ADDENDUM

Project: B.01 CT Site Prep

Addendum No.: 01

Date: 06/06/13

REMODEL SITE PLAN
SCALE: 1" = 10'-0"

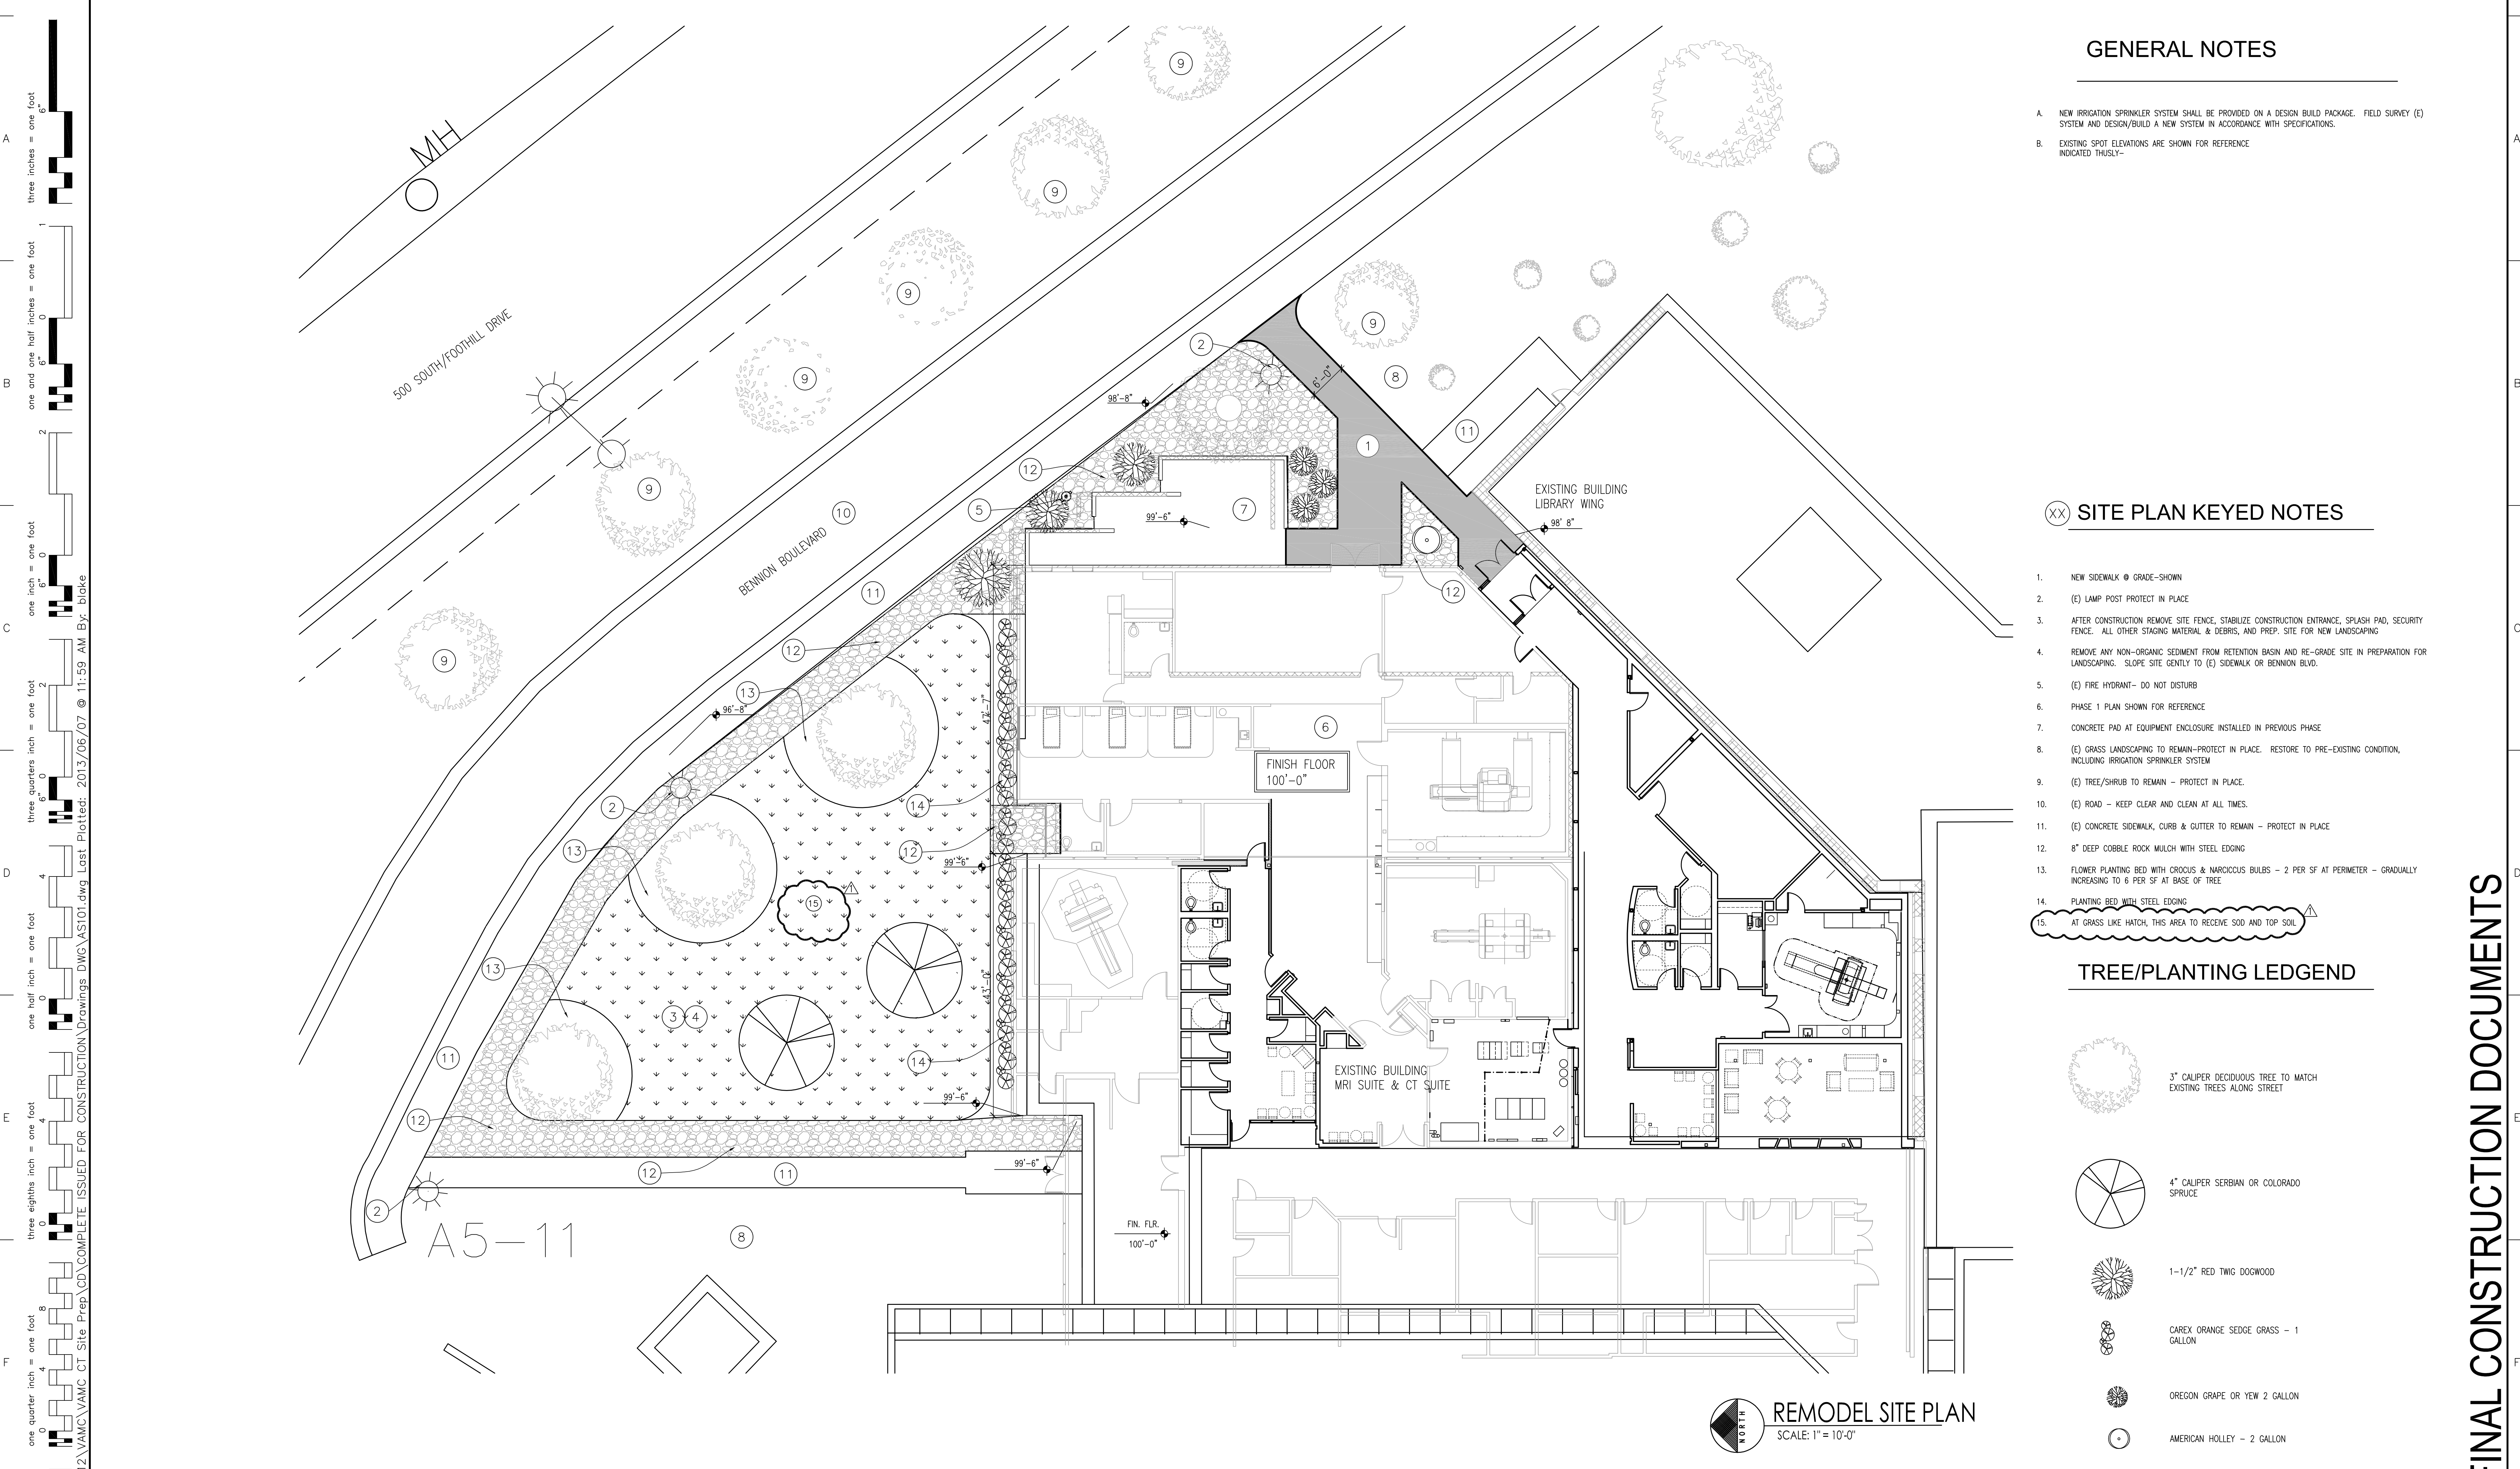
- a. Sheet AS101
 - i. *Add* the requirement for the landscaped area with the "grass-like" hatch pattern to receive sod and topsoil. Add Keynote 15.
- b. Sheet AD101
 - i. *Add* the requirement to remove a 16" wide x 96" high portion of the existing CMU shear wall at the East wall of the existing CT Room. Add Keynote 25.
 - ii. *Deleted* the requirement to remove existing EIFS from Keynote 12.
- c. Sheet AD401-
 - i. Remove Keynote 6.
- d. Sheet AE301 – Longitudinal Section A
 - i. *Delete* the keynote 18 reference at the ceiling of the corridor.

- 14. PLANTING BED WITH STEEL EDGING
- 15. AT GRASS LIKE HATCH, THIS AREA TO RECEIVE SOO AND TOP SOIL

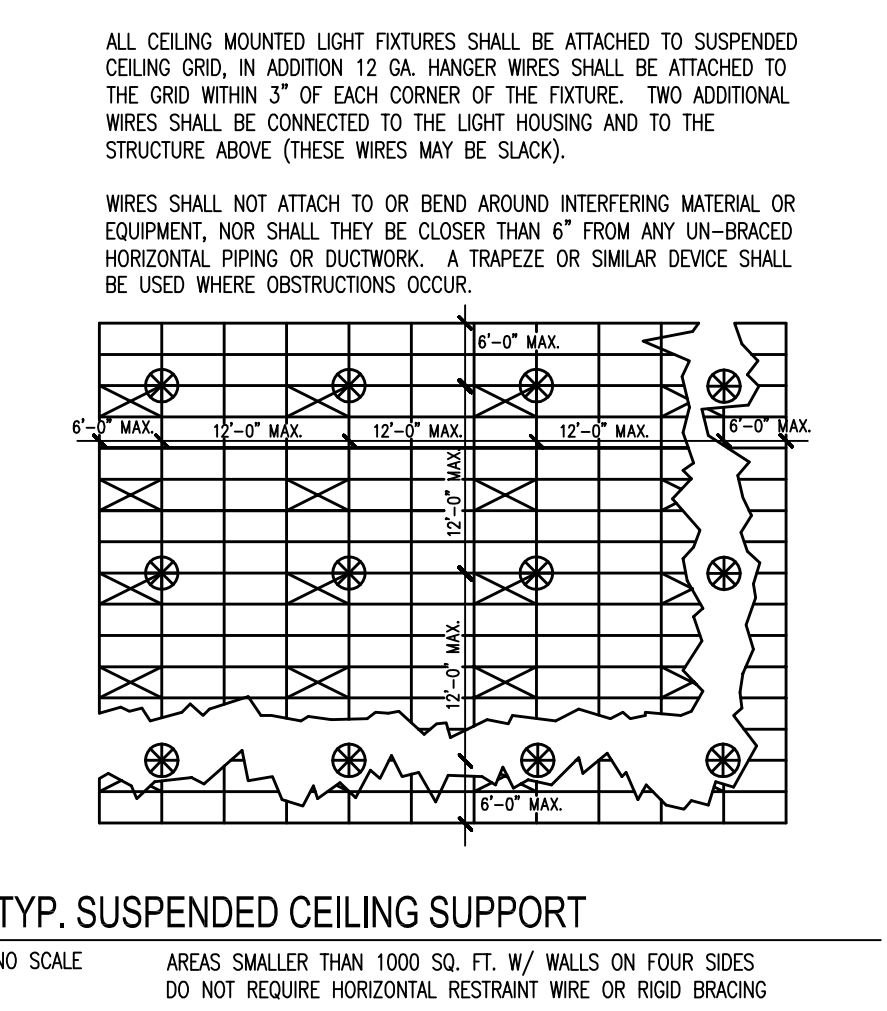
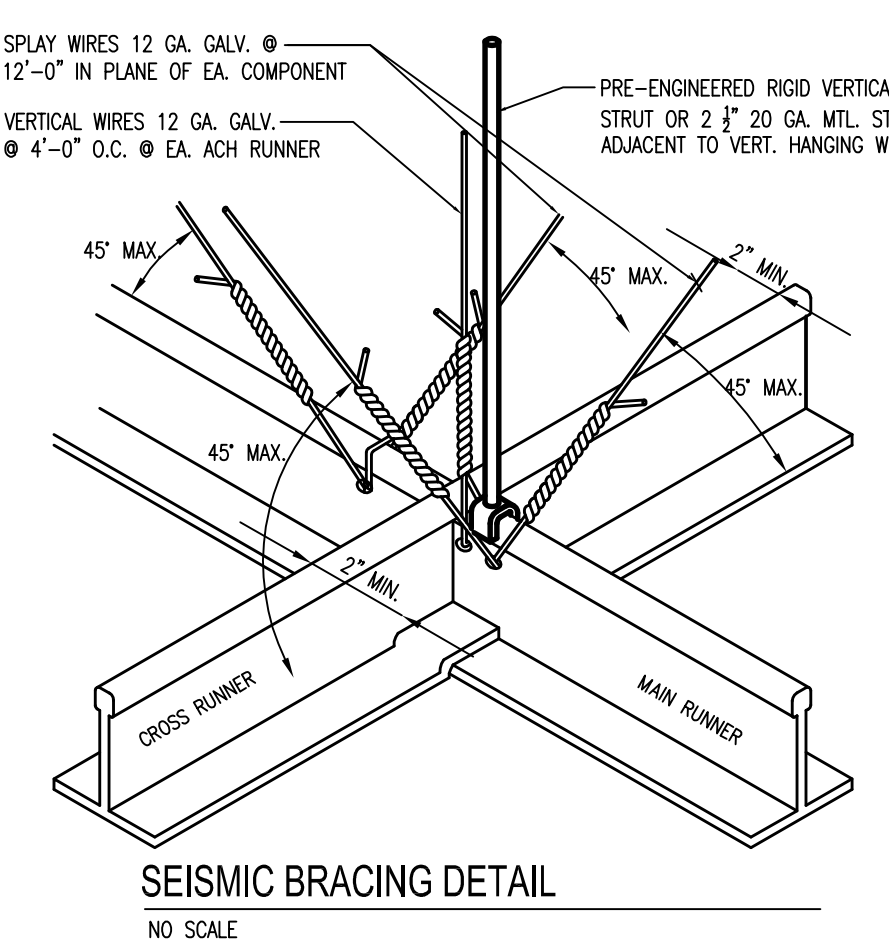
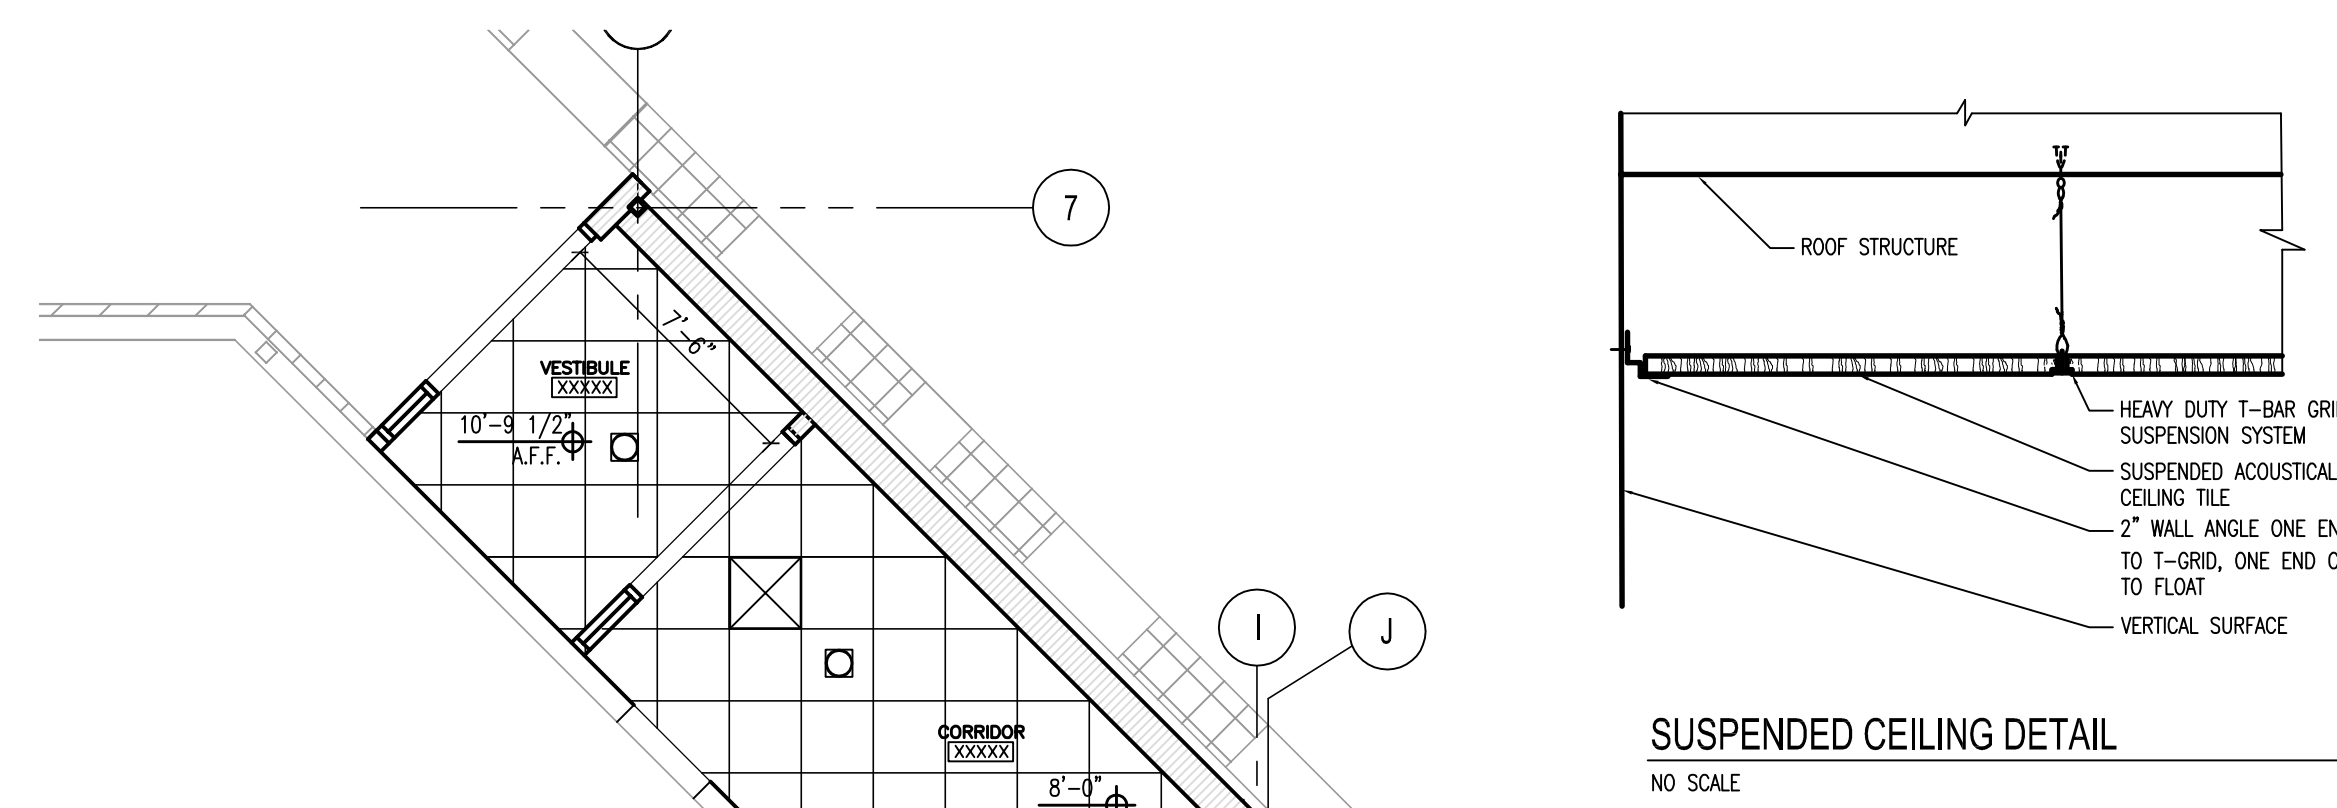
e. Sheet AE302 – Detail B

- i. *Add* the detail reference at the light cove from XX/AE603 to 14/AE603.

AE501

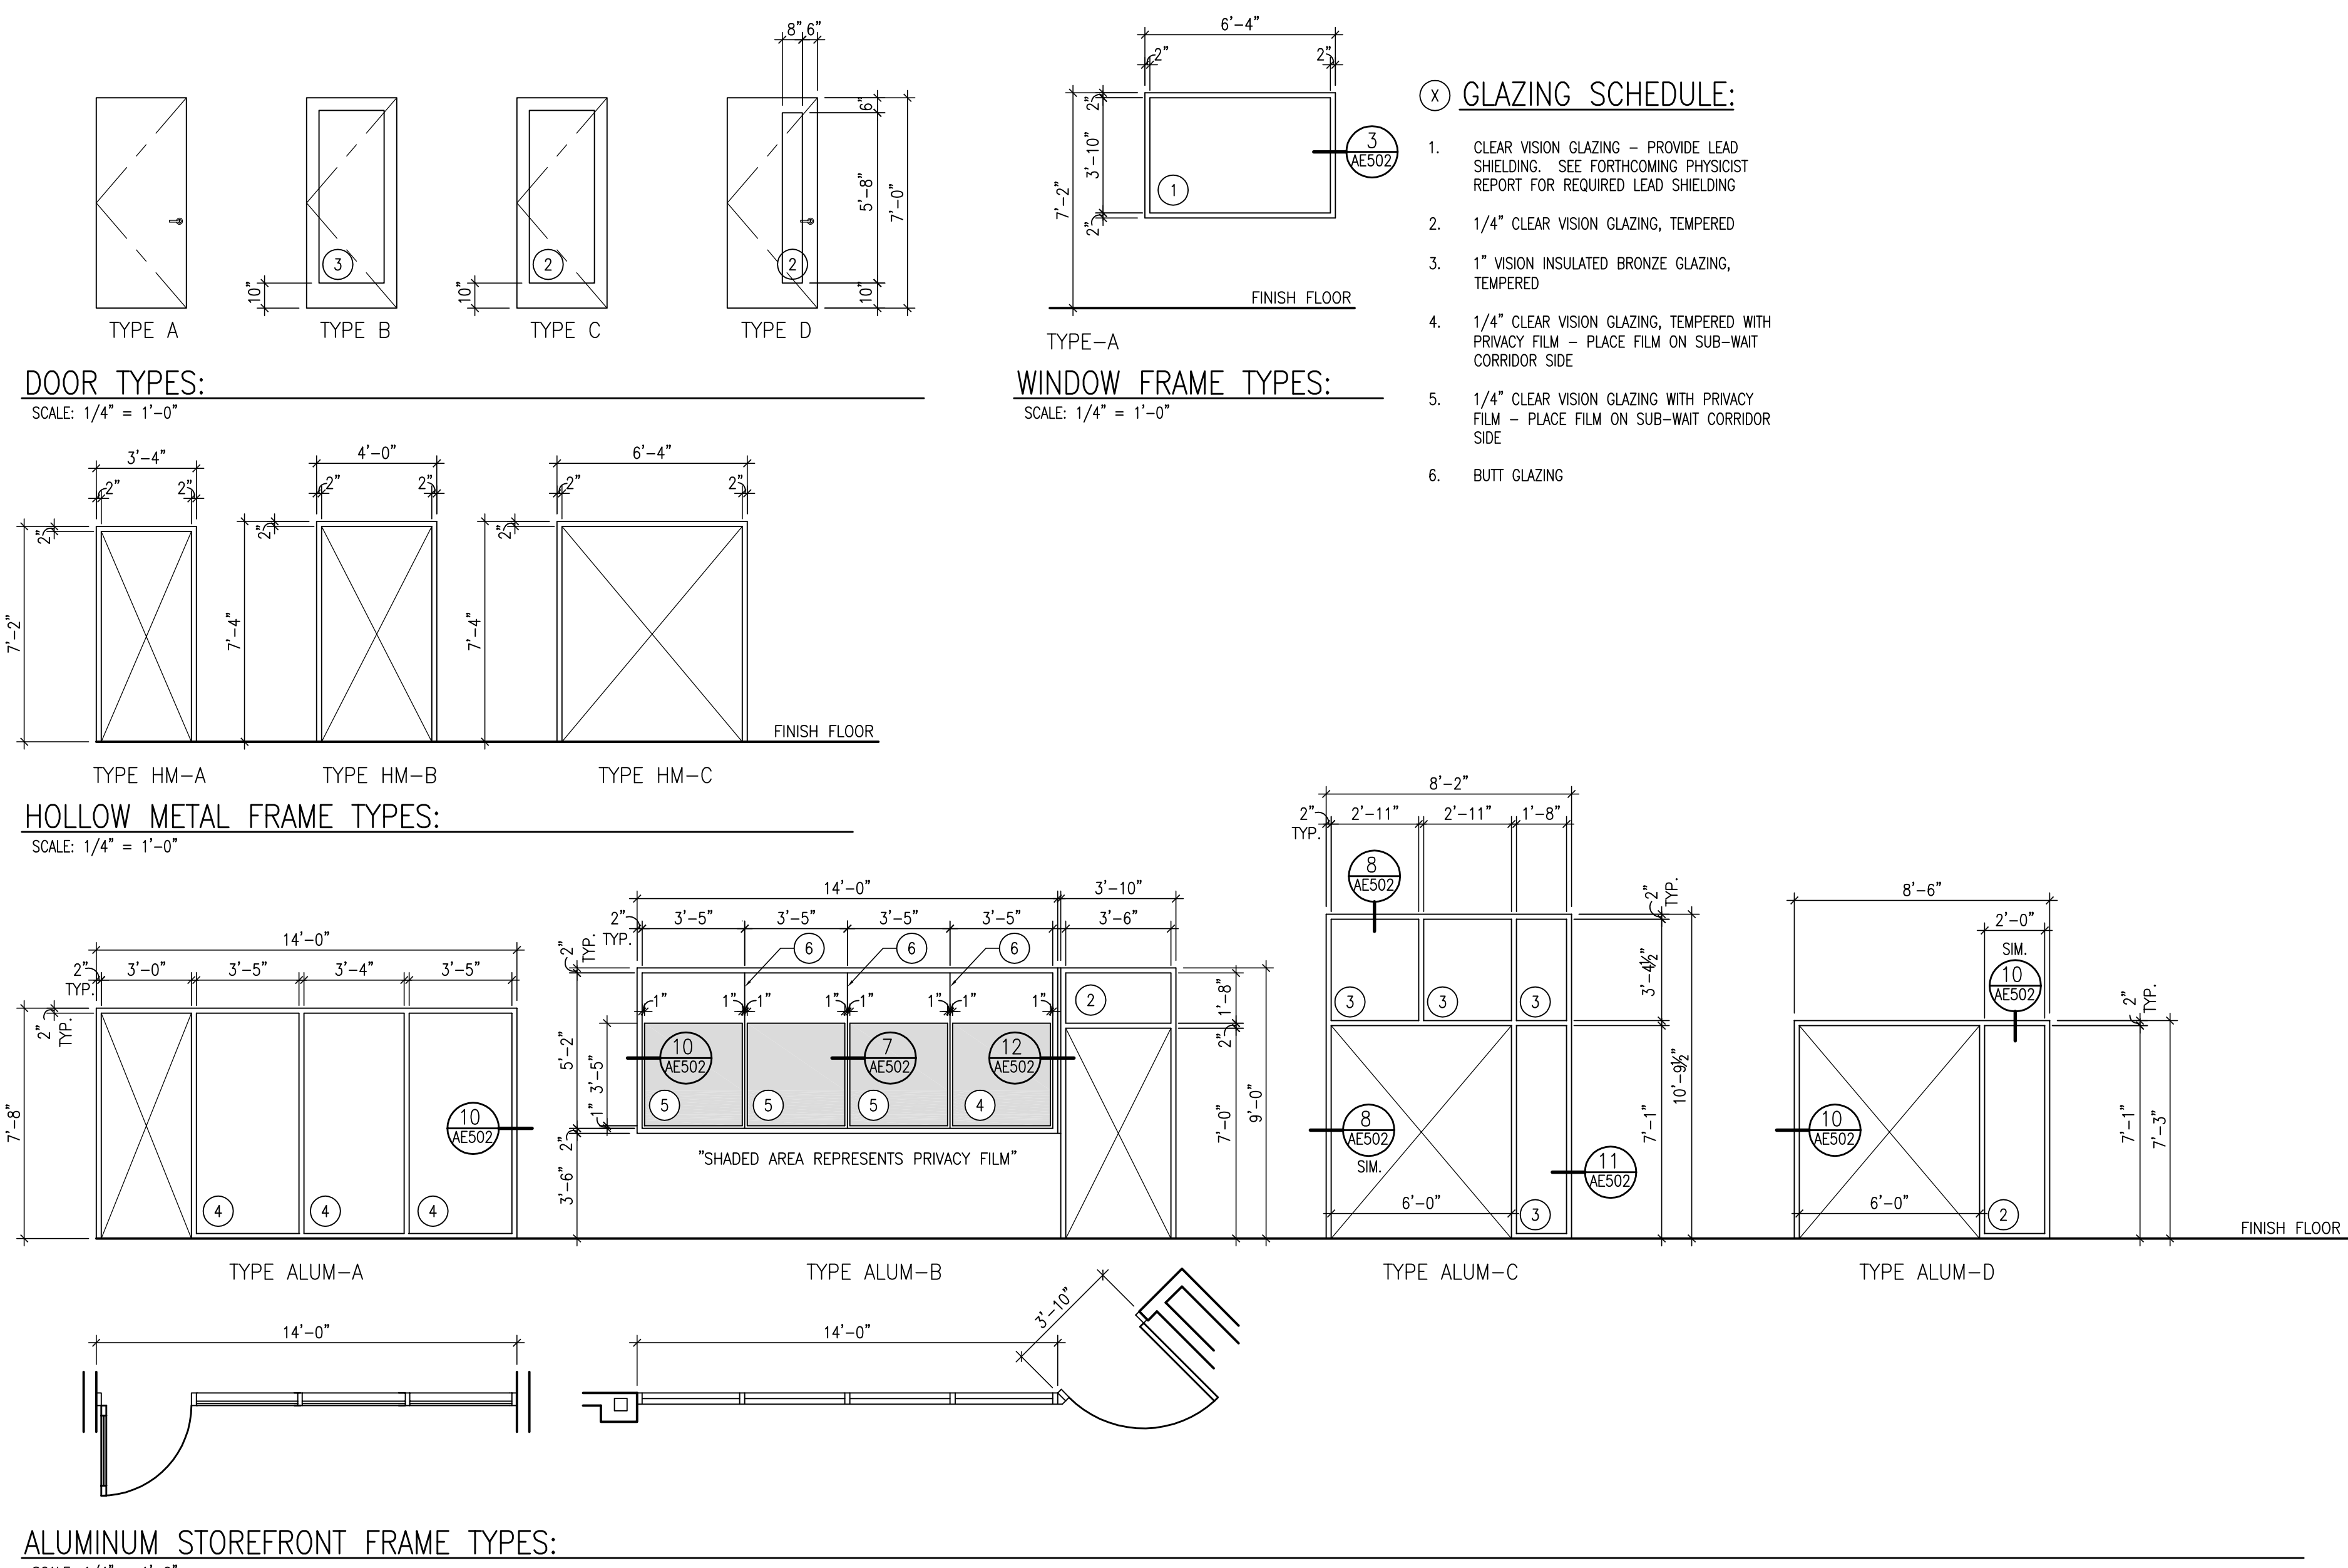
g. Sheet AE501

- i. Walls: Paint Color Change. Use SW7011 *Natural Choice* in lieu of SW7010 *White Duck*.
